Economic Commission for Europe**Inland Transport Committee****World Forum for Harmonization of Vehicle Regulations****Working Party on Lighting and Light Signalling (GRE)****Sixty-Ninth session**

**Regulations Nos. 3, 4, 6, 7, 19, 23, 38, 65, 69,
70, 77, 87, 91, 98, 112, 113, and 119****Proposal for Supplement 5 to the 01 series of amendments to
Regulation No. 112 (Headlamps emitting an asymmetrical
passing beam or a driving beam or both and equipped with
filament lamps and/ or light-emitting diode (led) modules)****Submitted by the expert from Germany***

Figure 1, shall be deleted:

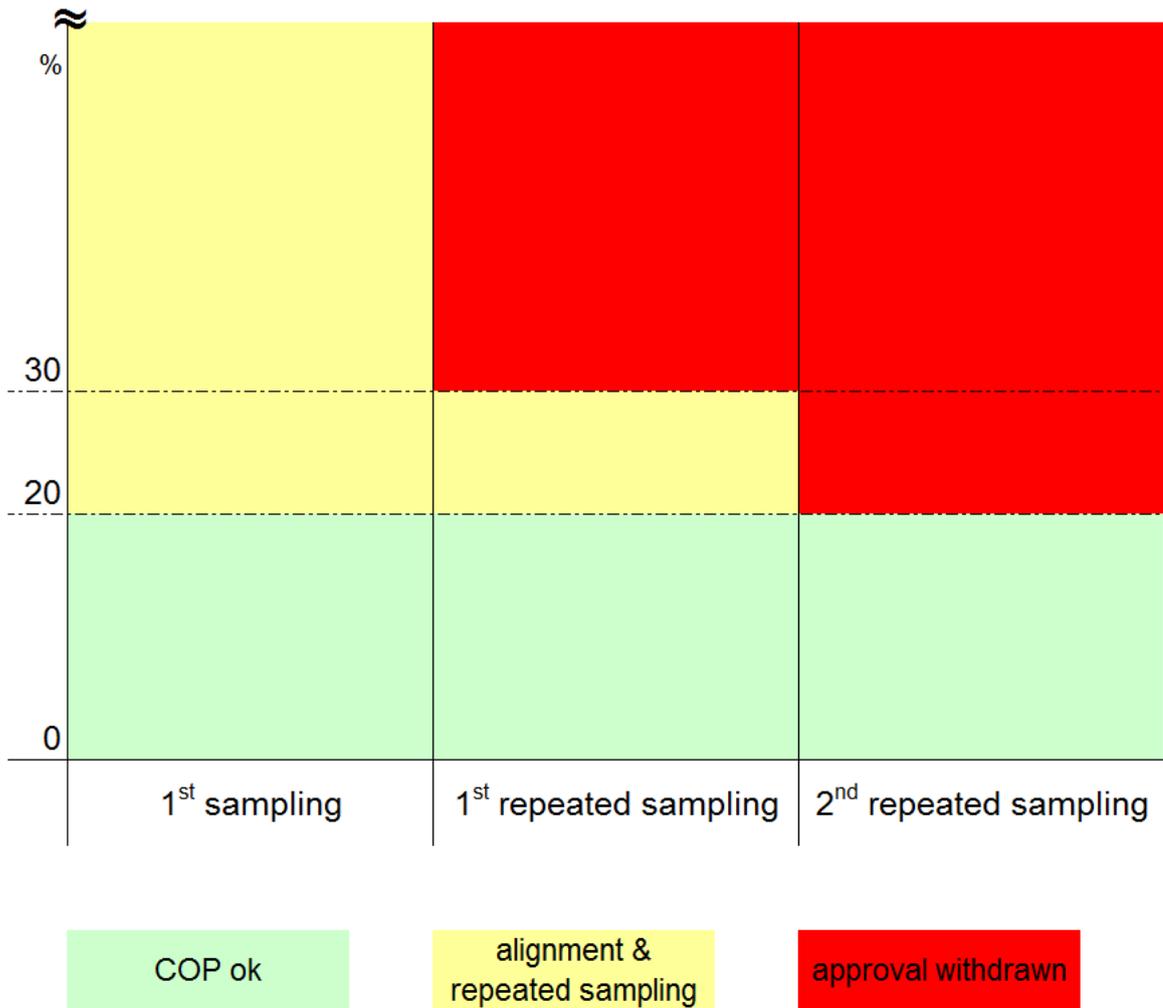
9. The existing Figure 1 could therefore be deleted, because this Figure has rather increased than clarified the confusion - and with the new simplified description it is not necessary anymore.
